**Fwd: Quality Landscape & Nursery Grading Project**

# TOWN OF SARATOGA QUALITY LANDSCAPE & NURSERY GRADING PROJECT

CONSTRUCTION DRAWINGS FOR:  
**QUALITY LANDSCAPE & NURSERY GRADING PROJECT**  
COVER

DATE: August 24, 2022  
 PROJECT: 220235  
 SHEET: **C3.0**

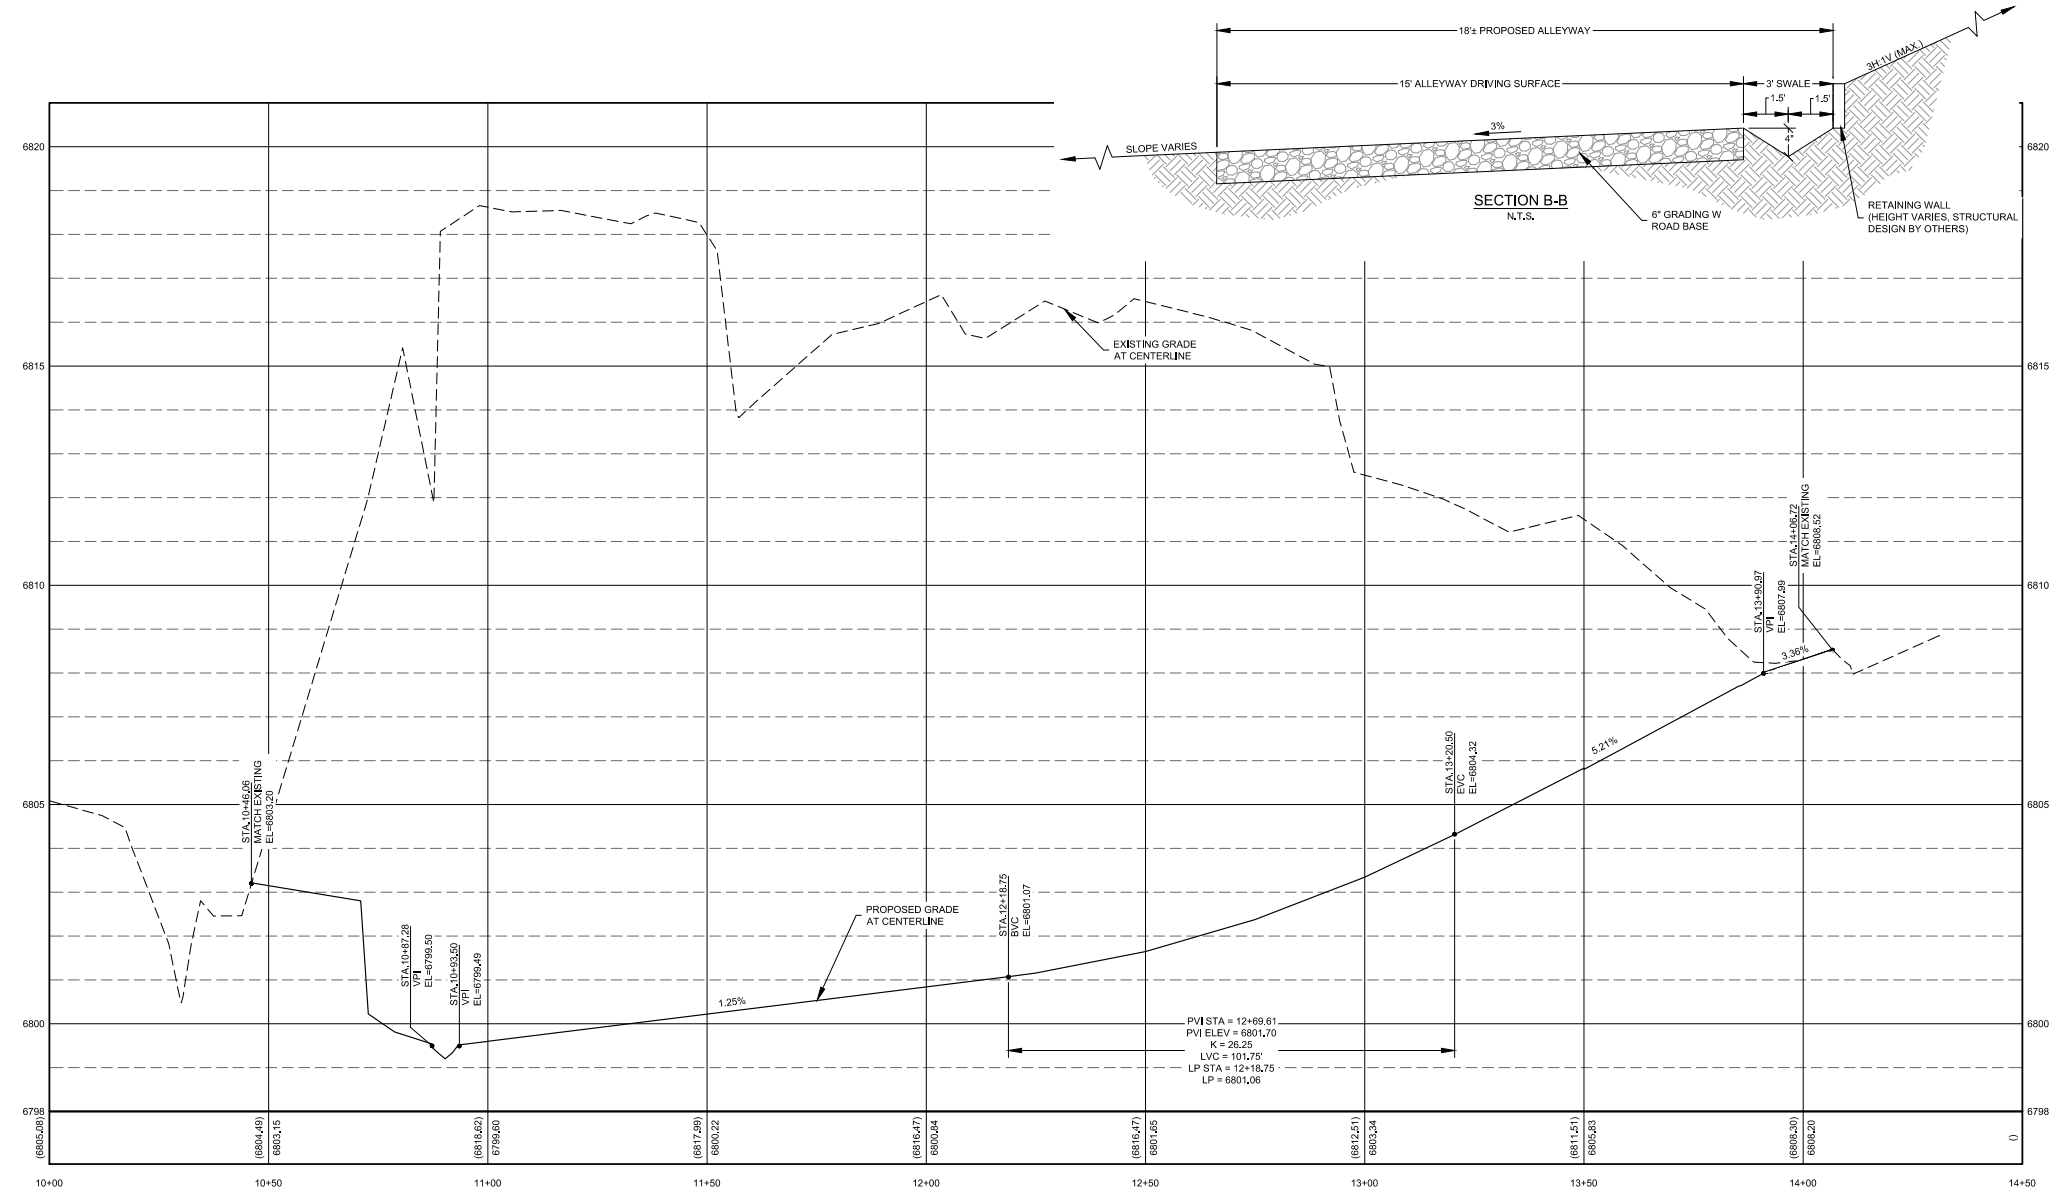
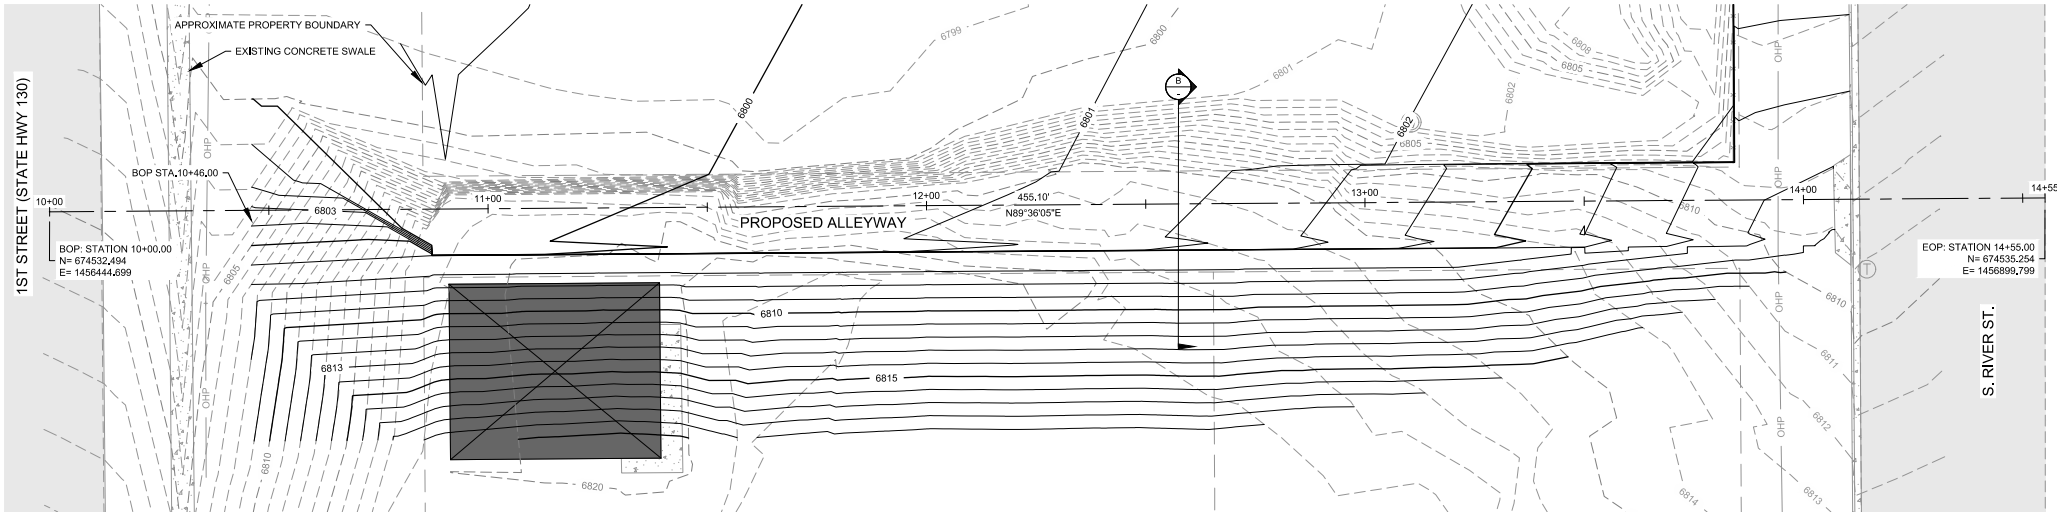
2. Are there any drainage or water quality requirements for runoff into the ditch from the Stevens' property? We currently show all runoff from this property entering the ditch. If there are any issues with this, we can show a retention pond at the low point or construct a berm, but both have their own drawbacks (namely loss of usable area on the Stevens' property).

3. Who owns the irrigation ditch, and would they allow grading next to it (north of the Stevens' property line)?
4. There is about 4' of elevation difference between the current and proposed ground elevation at the hot water well location. I do not have an understanding of what this particular well looks like or how it functions, but my initial thought is to cap it off for grading and then adjust the elevation of the riser after grading. Thoughts on this?

6. This plan assumes the town will allow for grading in the River St. ROW.
7. We show grading west of the property line in what we assume to be WYDOT ROW. You will have to coordinate with WYDOT if this is acceptable. Alternatively, we can shift our west grading boundary eastward.
